**LOCAL REVIEW BODY**

**NOTE OF CURRENT POSITION**

| <b>Site Address:</b> | <b>62A MAIN STREET SYMINGTON SOUTH<br/>AYRSHIRE KA1 5QG</b> |
| <b>Application:</b>  | <b>25/00545/APP – Erection of a Dwellinghouse</b>           |

| 23.016.31 | . |

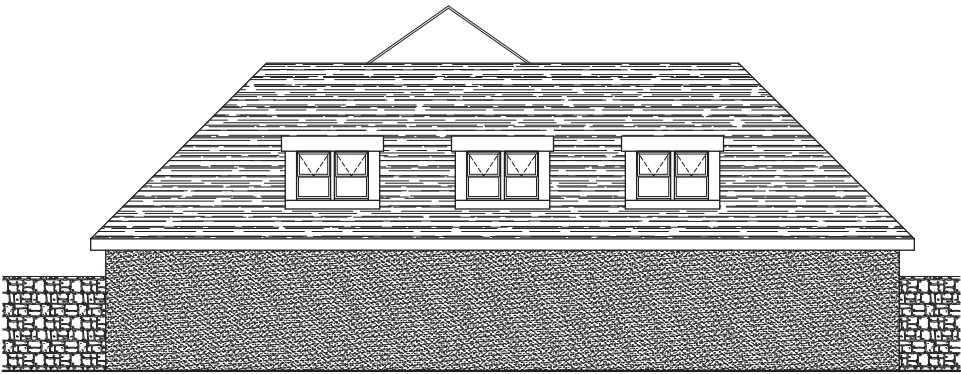
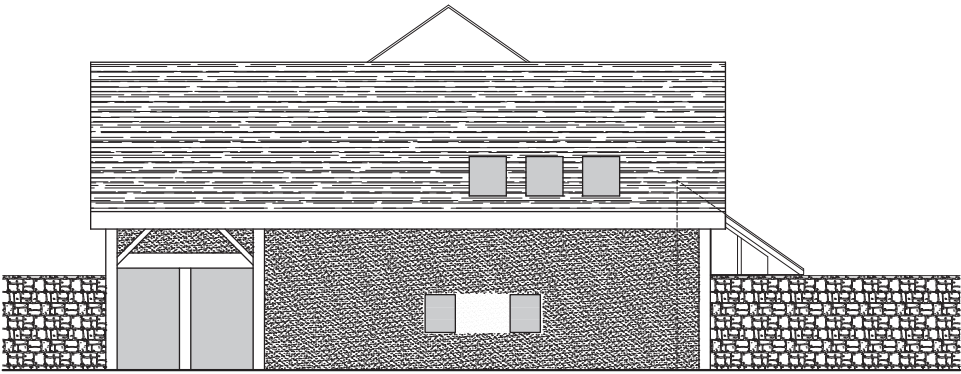
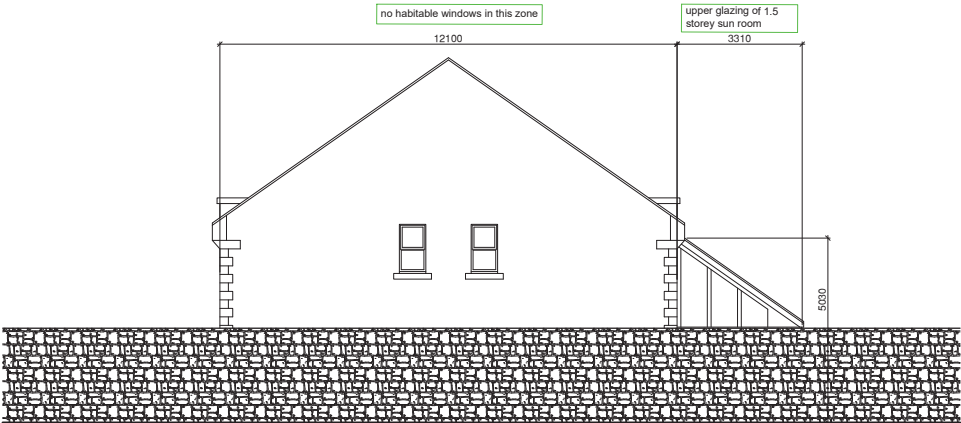
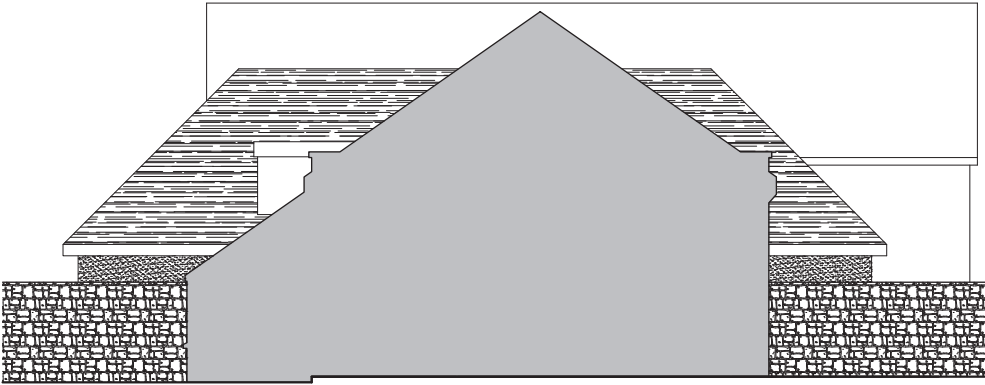
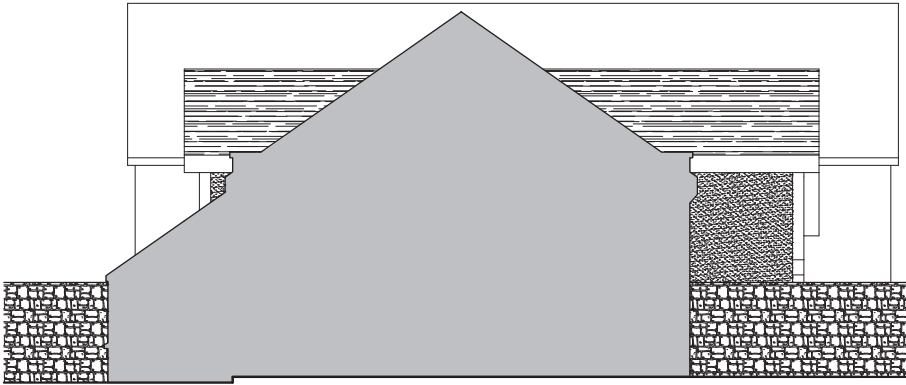
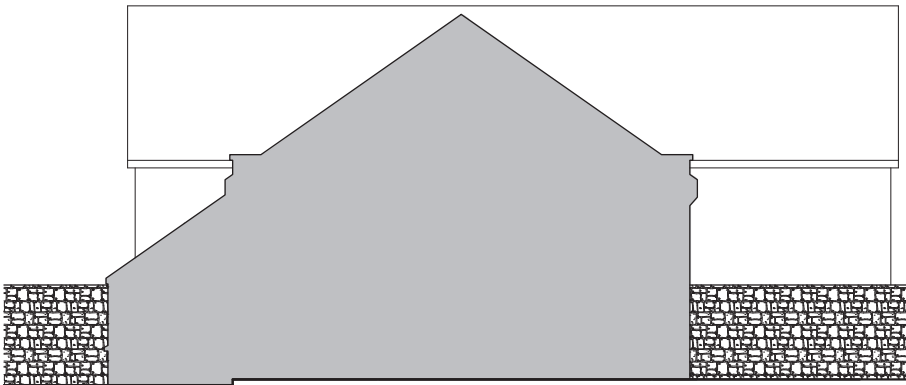
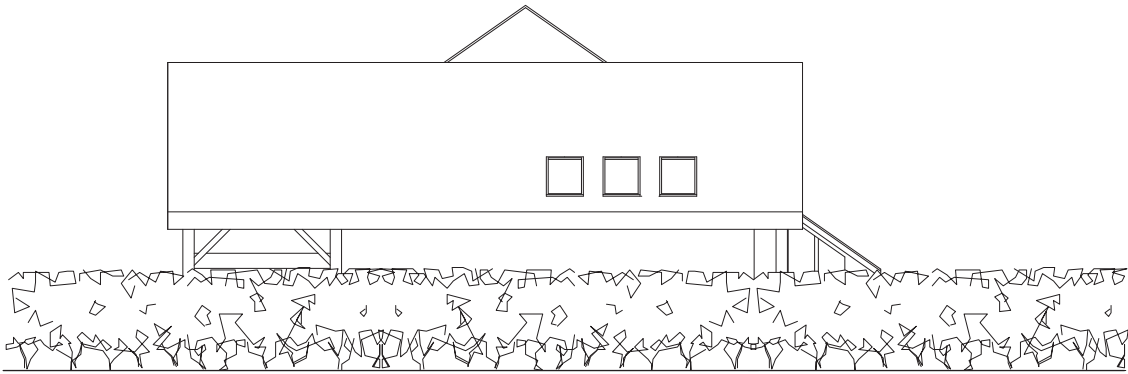
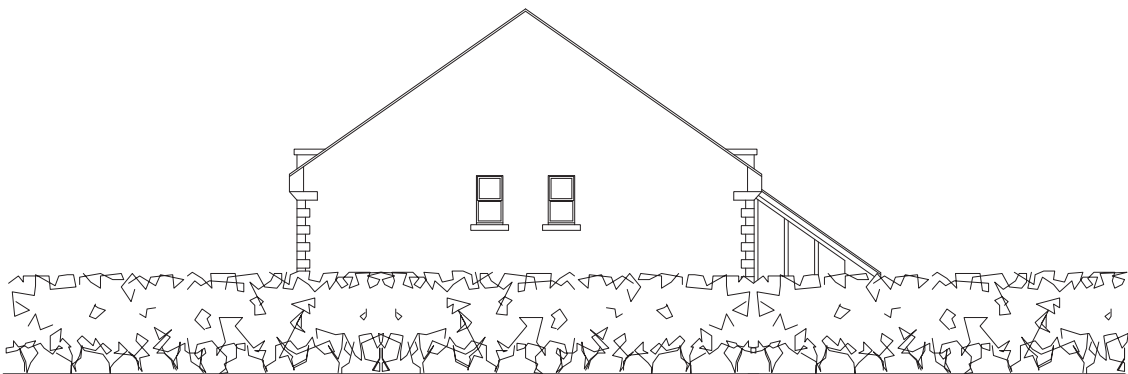
The appellant submitted comparative drawings showing a bungalow-style dwelling (replicating the donor property) that aligns with the Planning Authority's implied preference – see drawings 23.016.30, 23.016.31, 23.016.32, 23.016.33 & 23.016.34. These drawings demonstrate that:

The relationship between the appeal proposal and adjacent development is clearly illustrated on Drawing 23.016.31 (Street Elevation), which demonstrates that the proposal sits comfortably within the varied height and form of surrounding properties.
